**North Anna Power Station  
Updated Final Safety Analysis Report**

## Chapter 14: Initial Tests and Operation

14.2	AUGMENTATION OF VEPCO'S STAFF FOR INITIAL TEST AND OPERATION .....	14.2-1
Appendix 14A	NRC Questions and VEPCO's Responses Regarding the North Anna Power Station Unit 2 Modified Startup Physics Testing Program .....	14A-i

Figure 14A-1  
SECONDARY SOURCE LOCATIONS

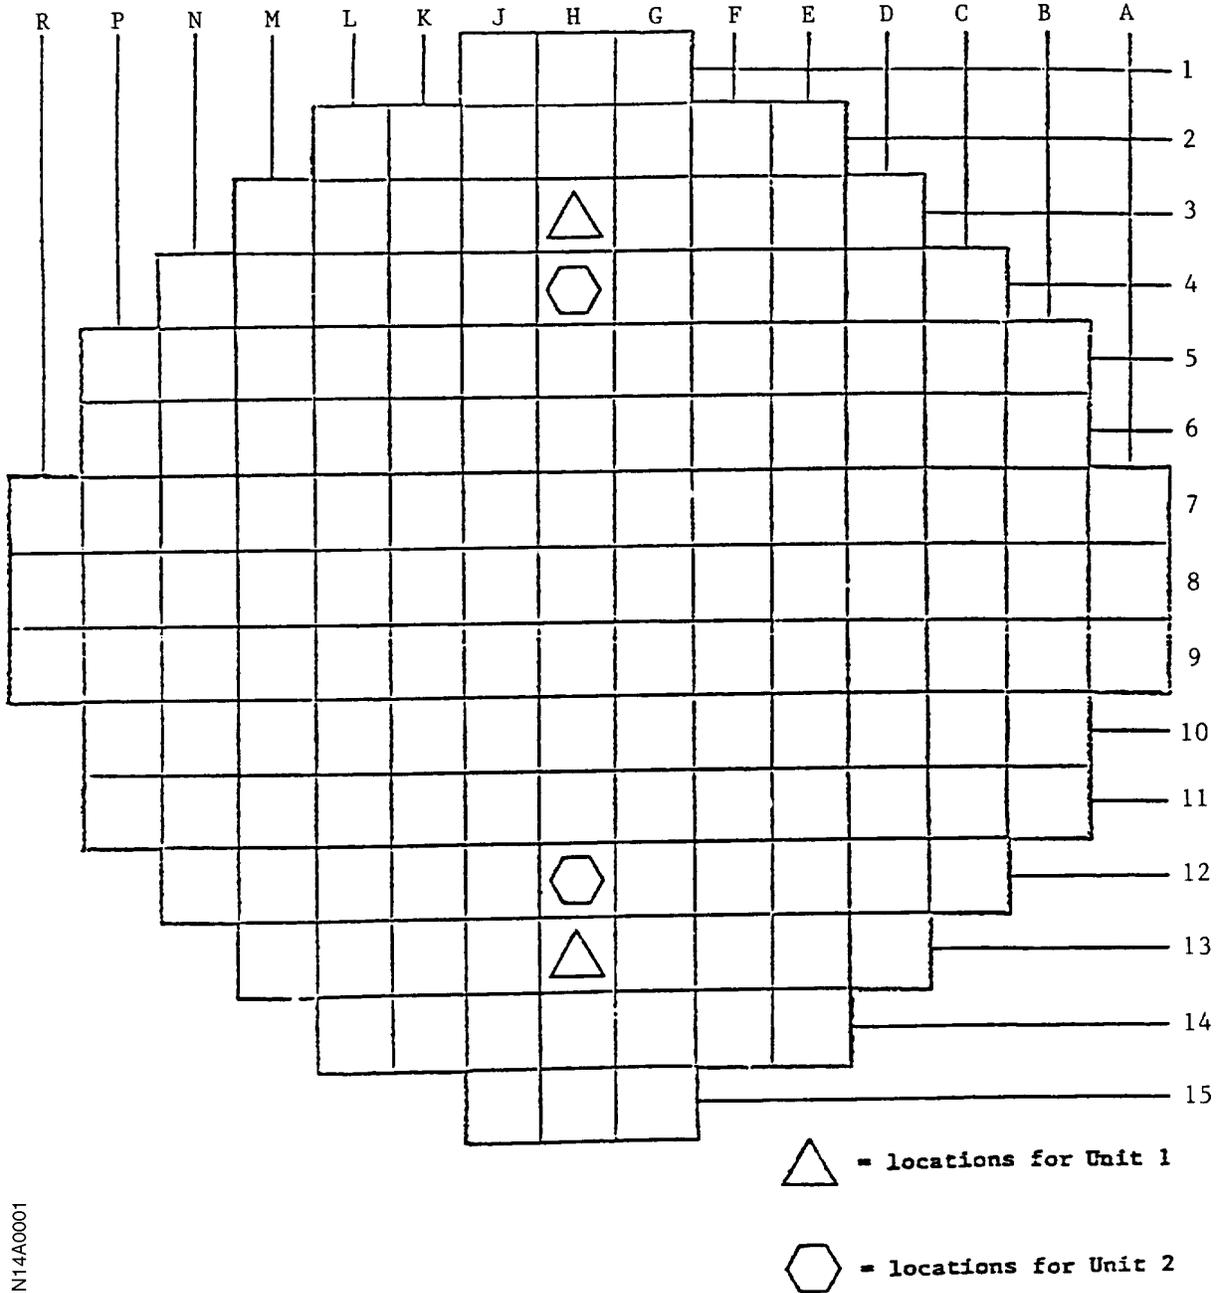
The core locations of the secondary sources for Unit 1 and Unit 2 are shown in Figure 14A-1. It is not expected that this change will lead to a measurable difference in the physics characteristics between the Unit 1 and Unit 2 cores.

Figure 14A-2  
PART LENGTH CONTROL ROD LOCATIONS (UNIT 1)

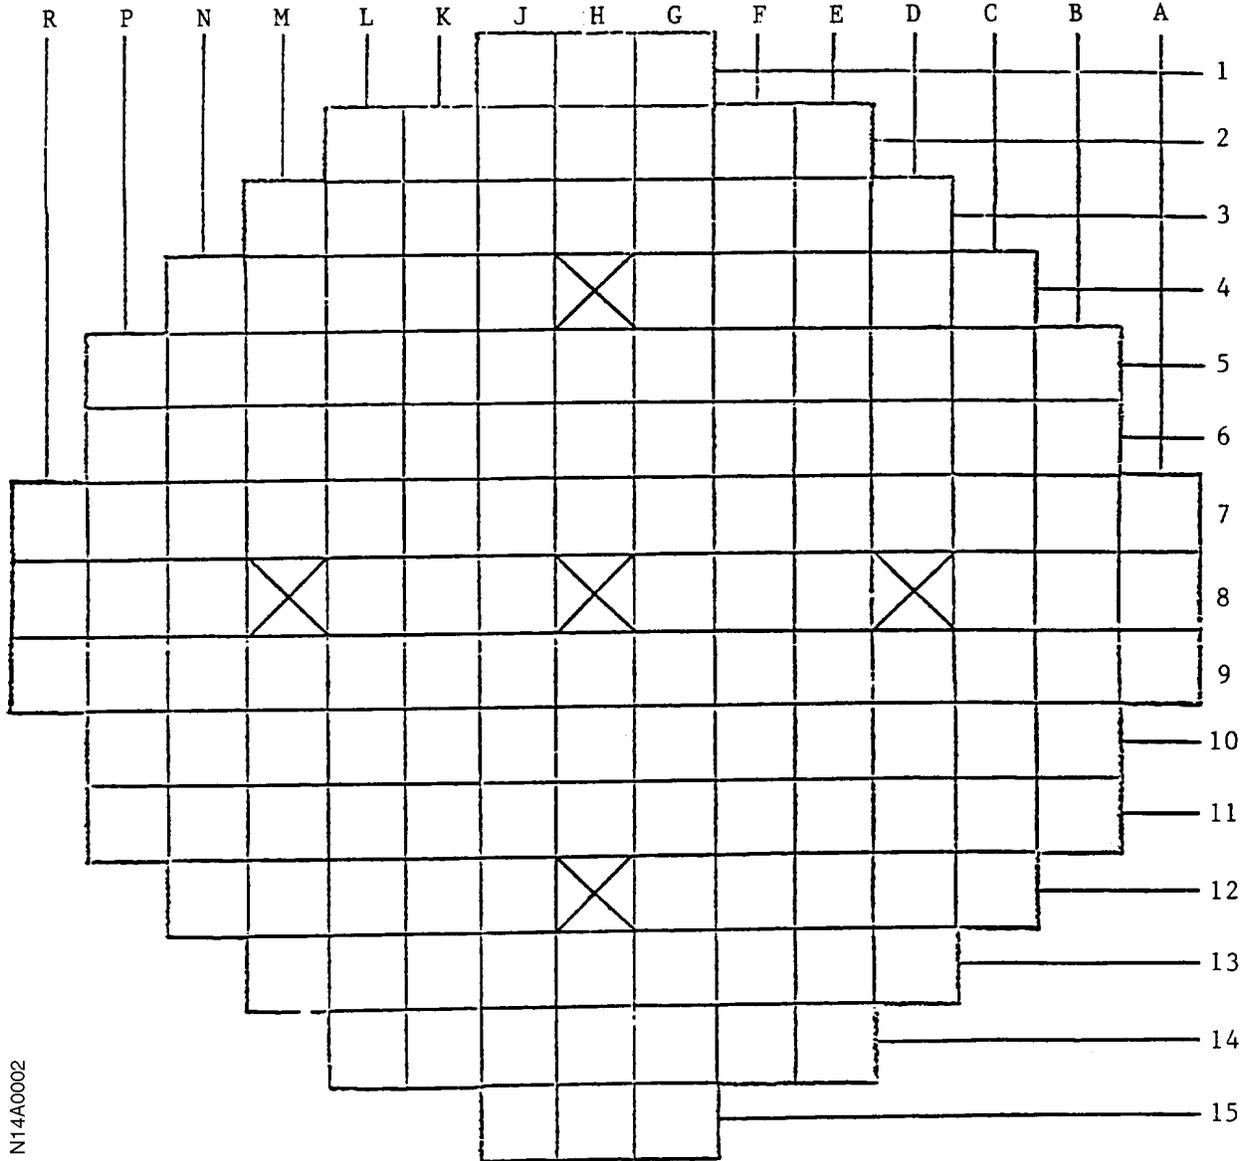
The core location of the part-length control rods for Unit 1 is shown in Figure 14A-2. This change will not lead to a measurable difference in the physics characteristics between the Unit 1 and Unit 2 cores because the use of the part-length control rods is not permitted during Unit 1 core operation. It is planned that these rods will be removed from Unit 1 following the end of Cycle 1 operation.
